Newcastle Inner City Bypass
Rankin Park to Jesmond

**Newcastle Inner City Bypass –
Rankin Park to Jesmond
Submissions and preferred
infrastructure report**

June 2018

Figure 5-1a
The project

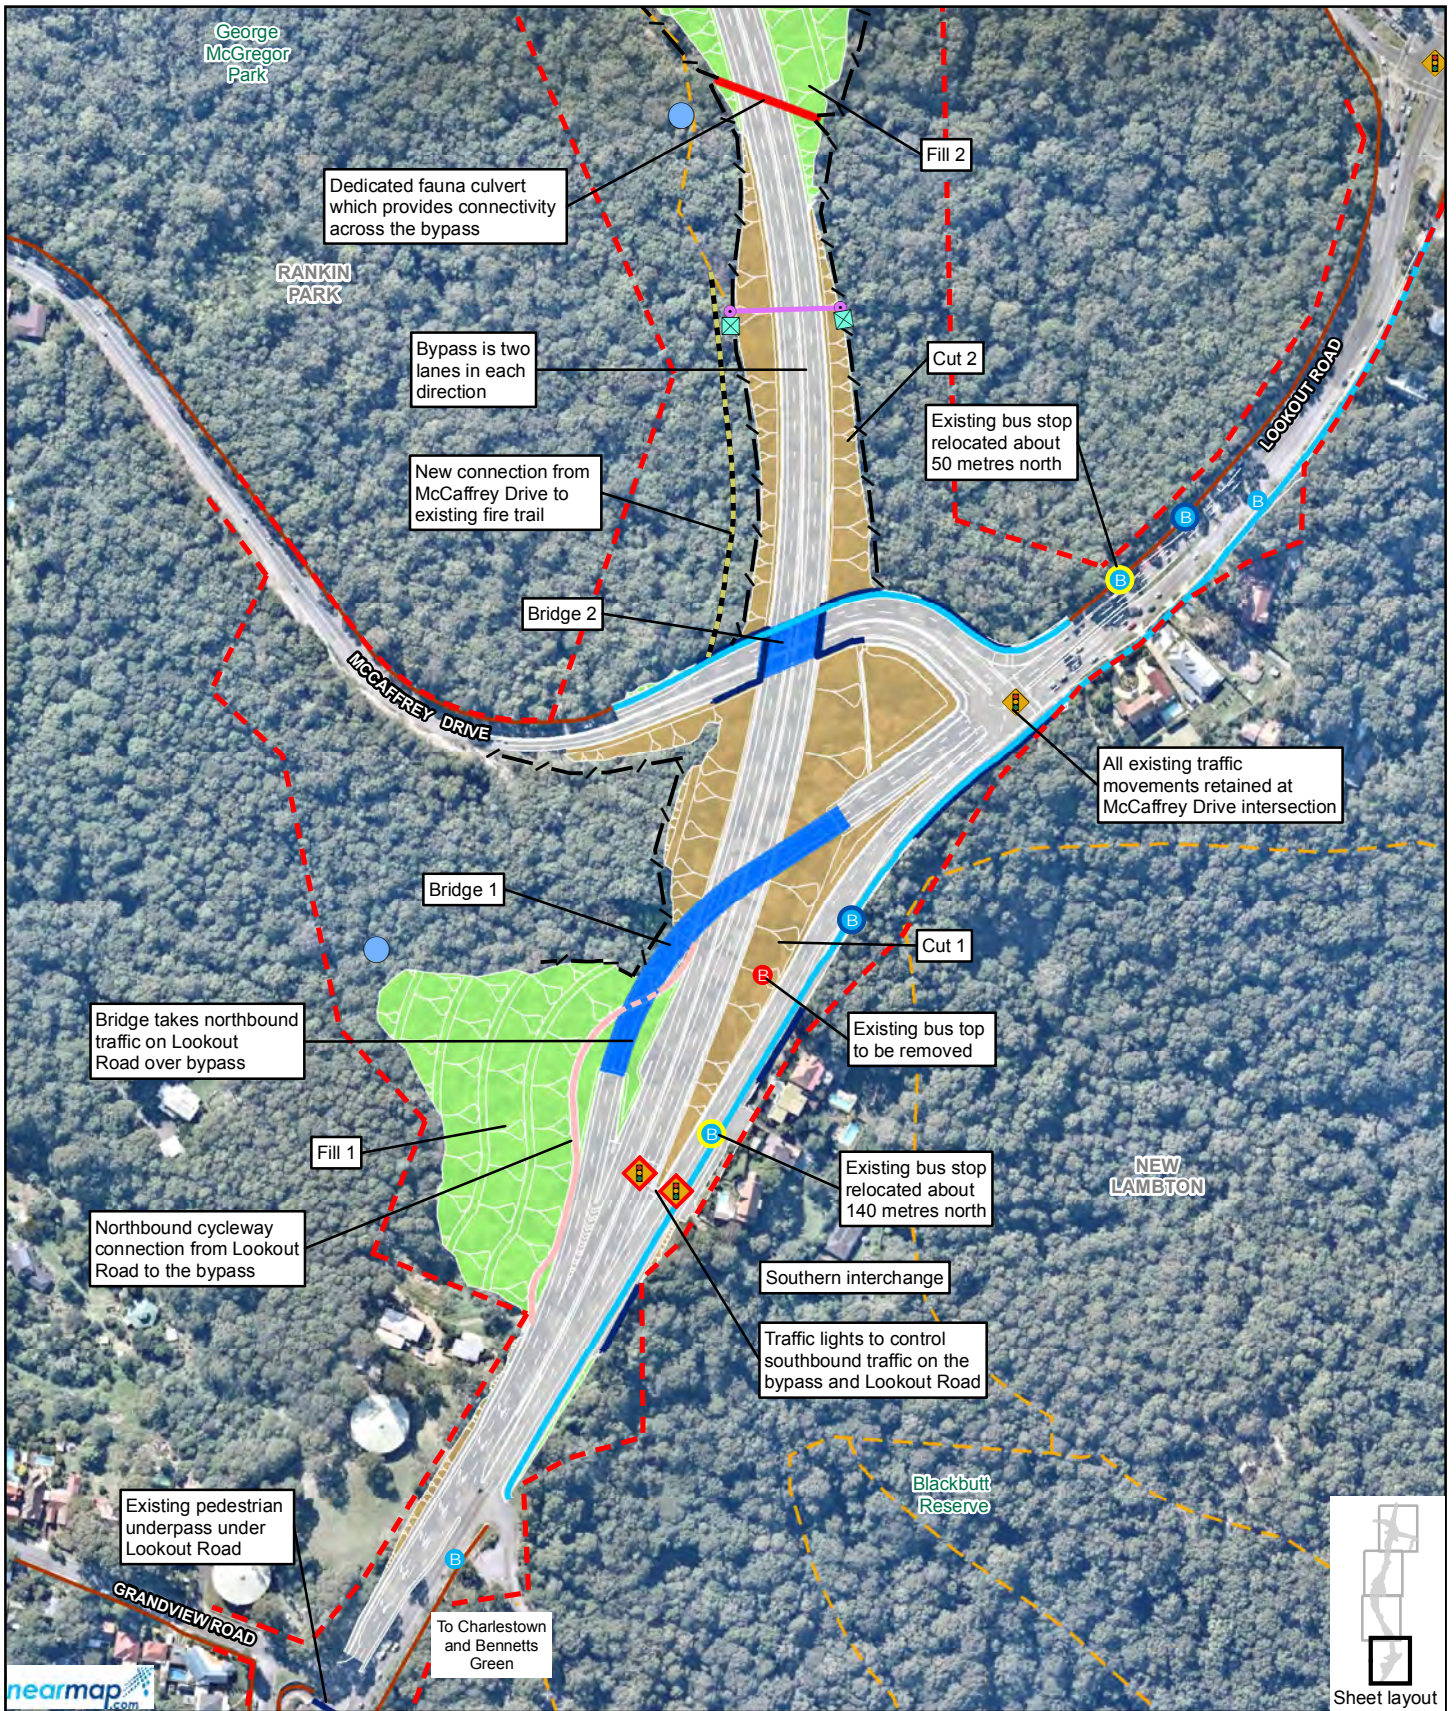
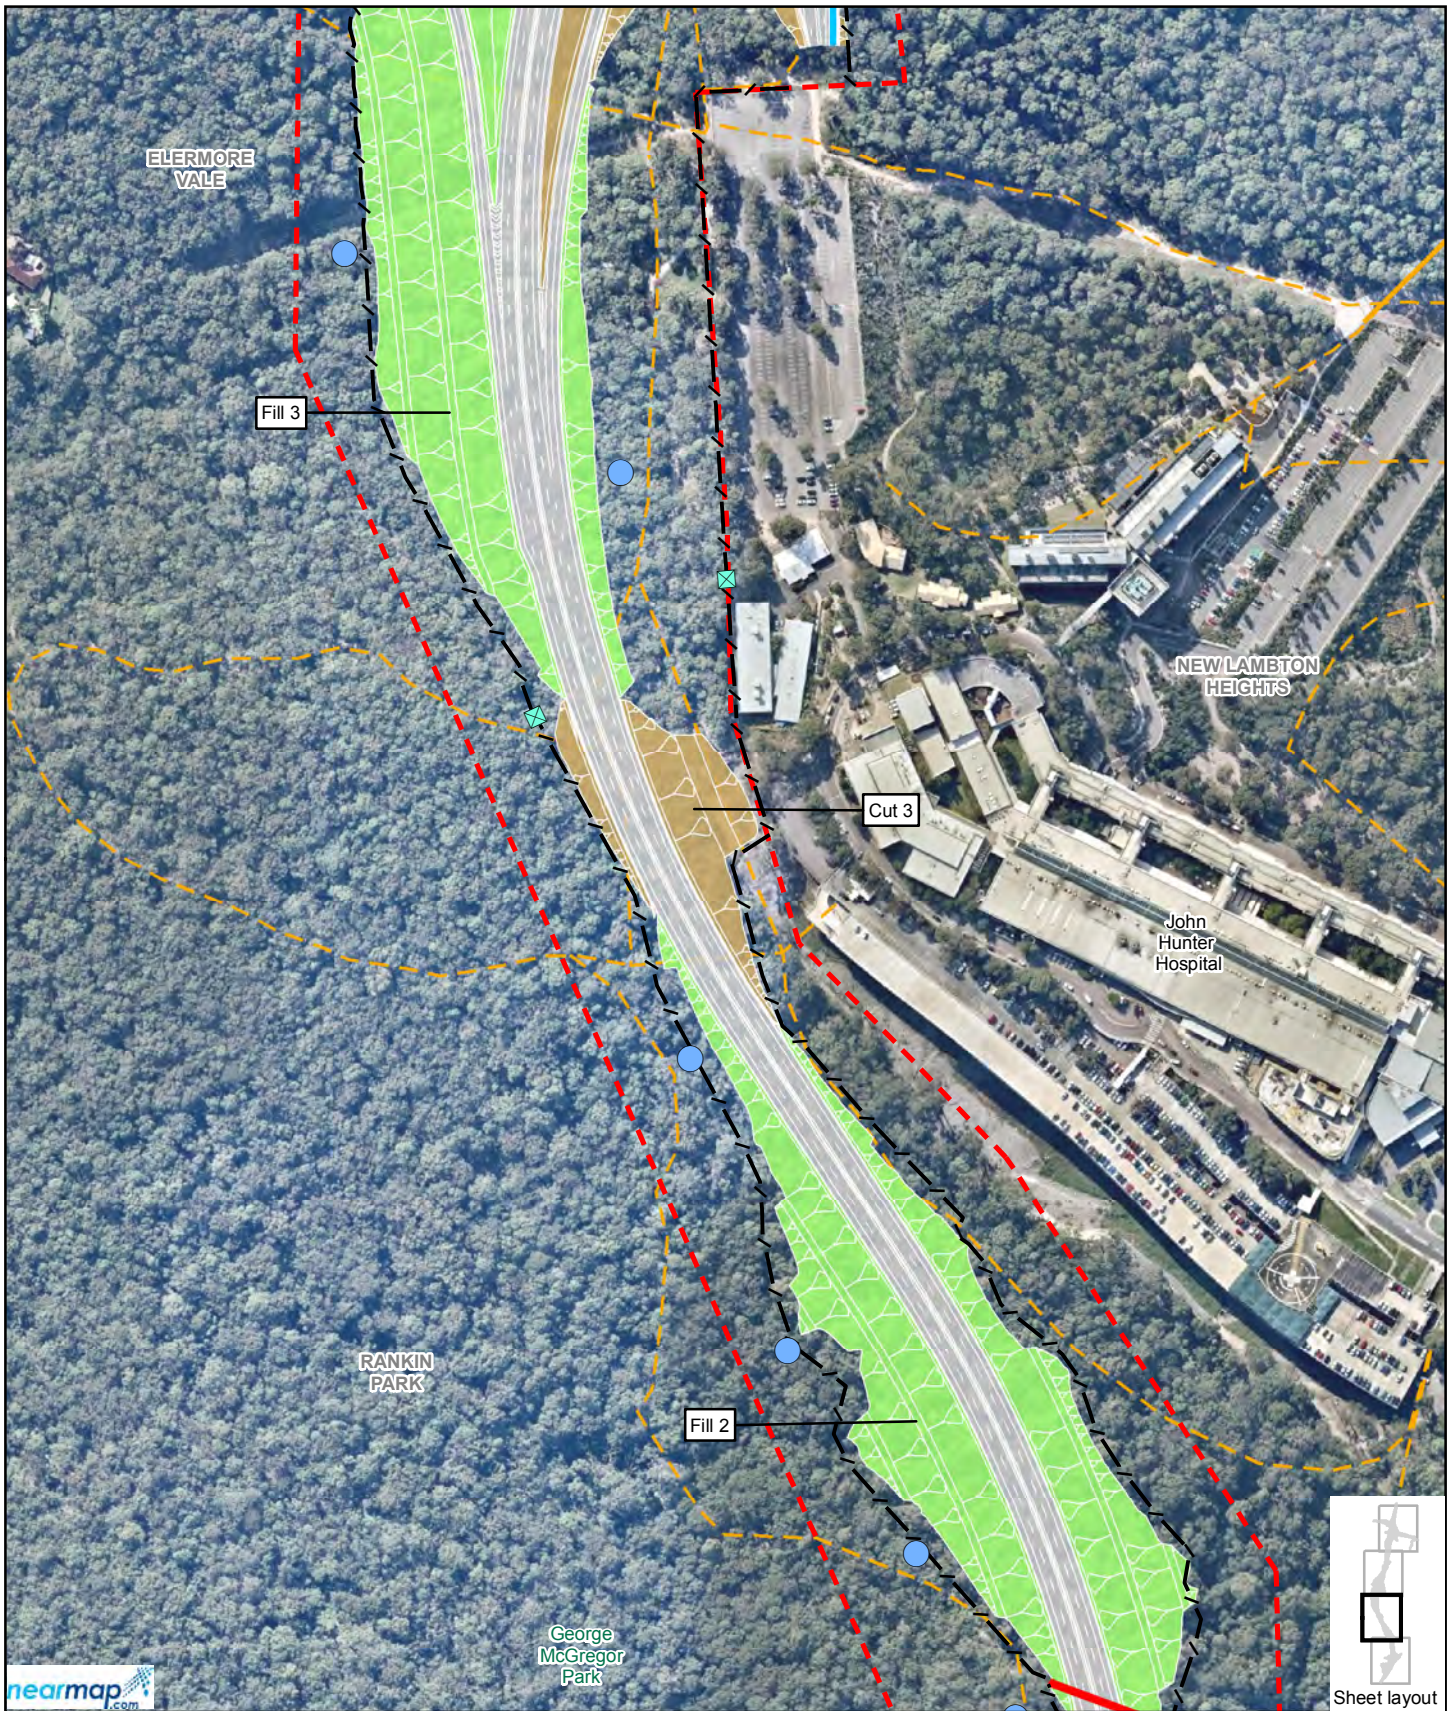
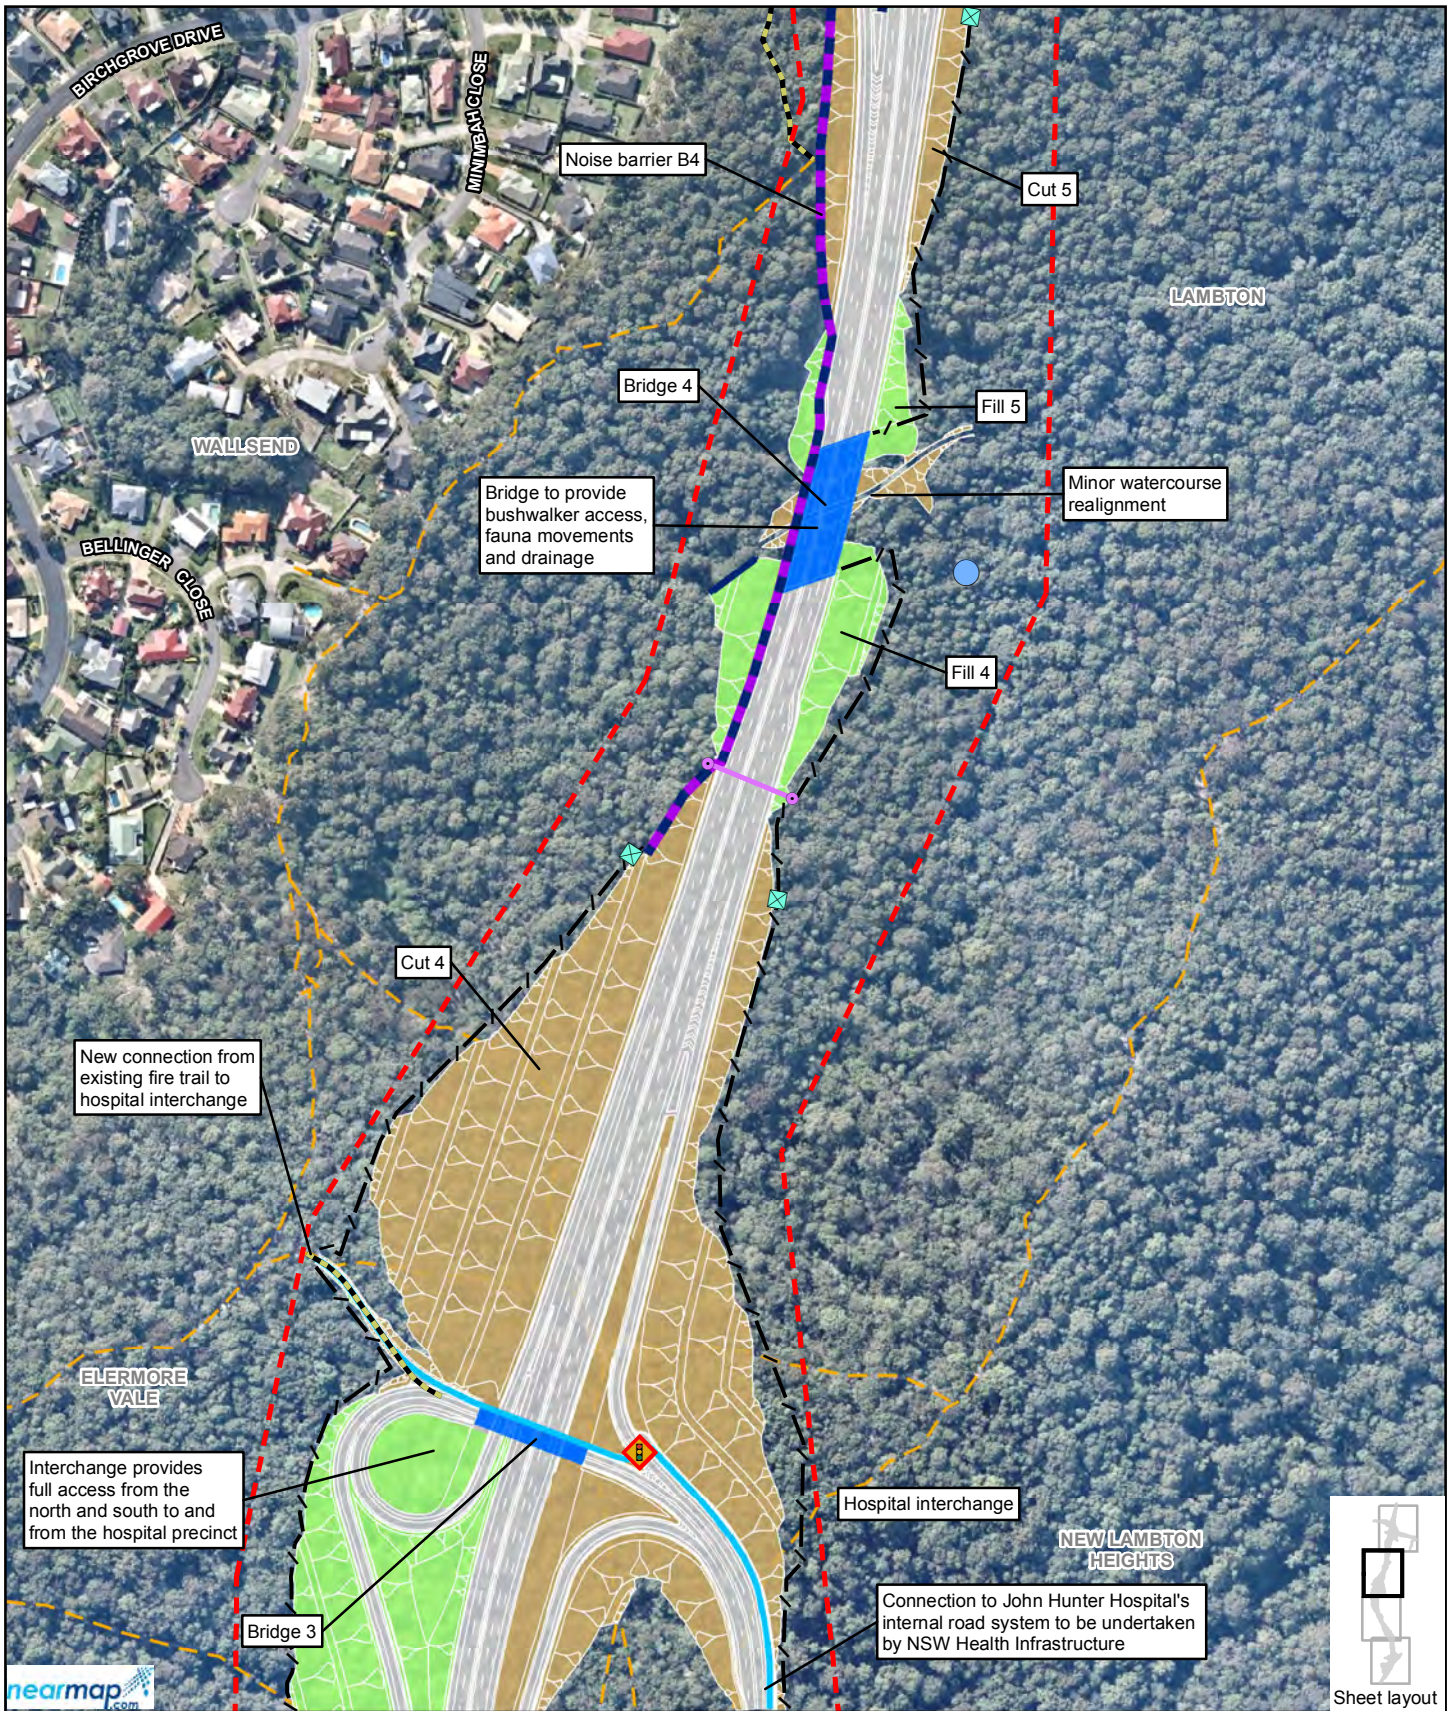
These are described in the following sections and key refinements are shown in Figure 5-1.

To assist with ongoing water quality control during operation of the project it is now proposed to retain and modify eight of the construction sedimentation basins as operational water quality treatment structures, as shown in Figure 5-1. Vegetated swales are also proposed to be constructed along batters as operational water quality treatment structures. Vegetated swales are proposed to be constructed where batter grades are suitable (where batter grades are between one and five per cent). These structures would capture stormwater runoff from all operational areas of the project (excluding existing roads).

Areas of cut and fill are shown in Figure 5-1 and detailed in Table 5-5. In Table 5-5 the change as a result of the design refinements is indicated in brackets. Further description of the proposed earthworks associated with cuts and fills are detailed in Section 5.5.10.
